UNITED STATES PATENT AND TRADEMARK OFFICE

APPLICATION NO.	FILING DATE	FIRST NAMED INVENTOR	ATTORNEY DOCKET NO.	CONFIRMATION NO.
10/670,524	09/26/2003	Koji Sakiyama	Q77632	6499
23373	7590	03/02/2005	EXAMINER	
SUGHRUE MION, PLLC 2100 PENNSYLVANIA AVENUE, N.W. SUITE 800 WASHINGTON, DC 20037			FIGUEROA, FELIX O	
			ART UNIT	PAPER NUMBER
			2833

Office Action Summary

DETAILED ACTION

FIG. 7

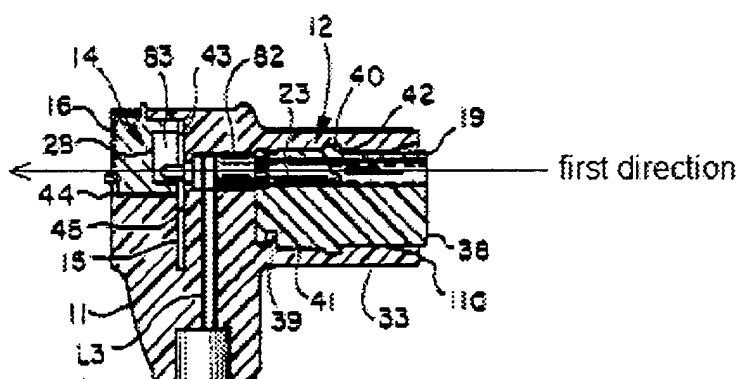
Guss discloses a connecting structure for auxiliary machinery and a cable (18) in which conductors (L1-L3) are surrounded by an insulating covering; and an auxiliary machinery (10) attached directly to this the cable the auxiliary machinery comprising: a

housing (11) comprising a board (15) on which electronic components (26,28) are mounted and to which a specific circuitry pattern has been formed; a connection terminal (23) connected to the circuitry pattern on the board and to at least one conductor among the conductors of the cable, and extending in a first direction (see following figure) there-between; and a molded part (16) for sealing a connection between the connection terminal of the housing and the at least one conductor of the cable, the molded part located near the connection in the first direction, wherein a first portion of the cable extends along an outer side of the auxiliary machinery.

Guss discloses substantially the claimed invention except for flat configuration of the conductors. Fuchs teaches the use of conductors arrayed in a flat configuration. This flat configuration permits a reduction of the size/profile of the connecting structure. Therefore, it would have been obvious to a person of ordinary skill in the art at the time the invention was made to form the conductor of Guss in a flat configuration, as taught by Fuchs, to reduce the size/profile of the connecting structure.

Guss, as modified, discloses the auxiliary machinery being coupled to an end of the cable at a first end portion (near top of Fig.7) of the housing of the auxiliary machinery, the at least one conductors being connected to a proximal end portion (27) of the connecting terminal along the first direction that is perpendicular to axes of the conductors. Guss discloses substantially the claimed invention except for the cable laying along the outside of the housing. Boyle teaches a connector having a cable (12) installed so as to extend along the outside of the housing (16,18) over a specific

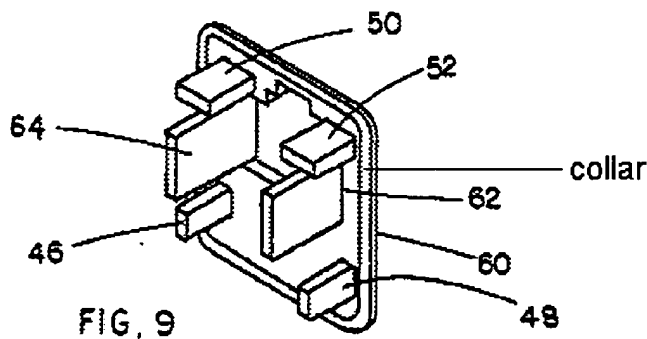
distance from a first end (top-right side of Fig.1) to a second portion (near bottom of Fig.1) of the housing, and at the second portion the axes of the conductors bend in a direction perpendicular to the side of the housing (near the bottom of Fig.1) to provide strain relief to the cable connection. Therefore, it would have been obvious to a person of ordinary skill in the art at the time the invention was made to place the cable of Fuchs laying along the outside of the housing, as taught by Boyle, to provide strain relief to the cable connection.
